Title: **STAGE 1&2 ROAD SAFETY AUDIT**

Proposed Residential Development, Kingswood, Co. Dublin

Client: **Pinnacle Consulting Engineers**

Report reference: **1417R01**

Drawing P210514-PIN-XX-DR-D-0001-SI P05, General Layout.

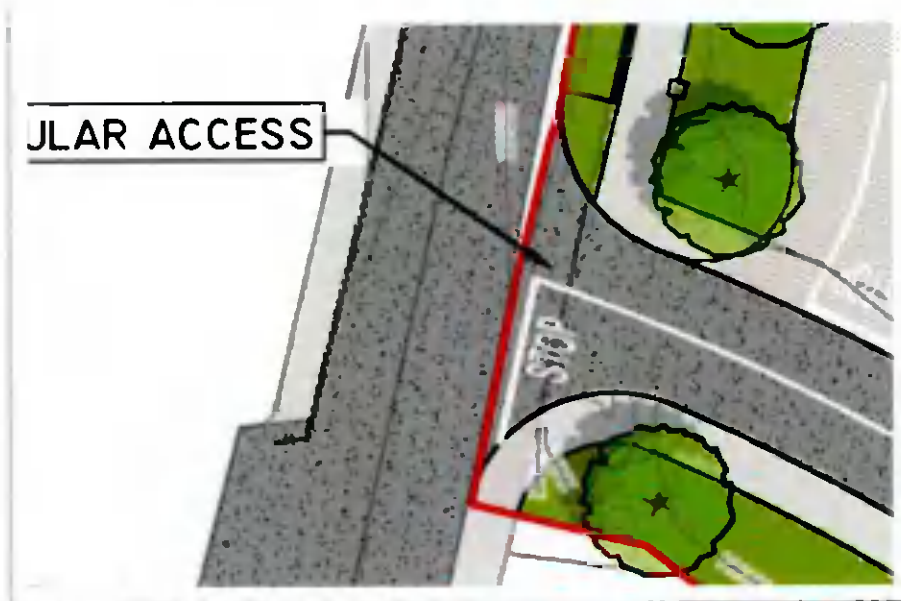
It is proposed to provide a set-back footpath along the development boundary with Old Naas Road and the existing stone wall is to be retained. There is a risk that this private footpath (noted that it is planned to be taken in charge – Drawing 21003-TJOC-ZZ-ZZDR-C-0079 Rev C01) may not be accessible to all members of the public walking from the Cheeverstown Road roundabout to a destination west of the site. It appears that steps are proposed. A lack of pedestrian facilities accessible to all would lead to pedestrians travelling on the carriageway where they would be at high risk of being struck by a passing vehicle.

It is recommended that a footpath be provided along the entire site boundary with access for all including the mobility impaired.

Paragraph No. in Safety Audit Report	Problem accepted (yes/no)	Recommended measure accepted (yes/no)	Alternative measures (describe)	Alternative measures accepted by Auditors (Yes/No)
3.1	Yes	Yes		
3.2	Yes	No	As per Item 3.1, additional 2 No. uncontrolled crossings will be provided to the northern and southern boundaries of the development. This will provide a direct link for pedestrians north of the development to Kingswood Village in the south. Access to the development (including the ramp/stairs) will remain open to the public.	Yes
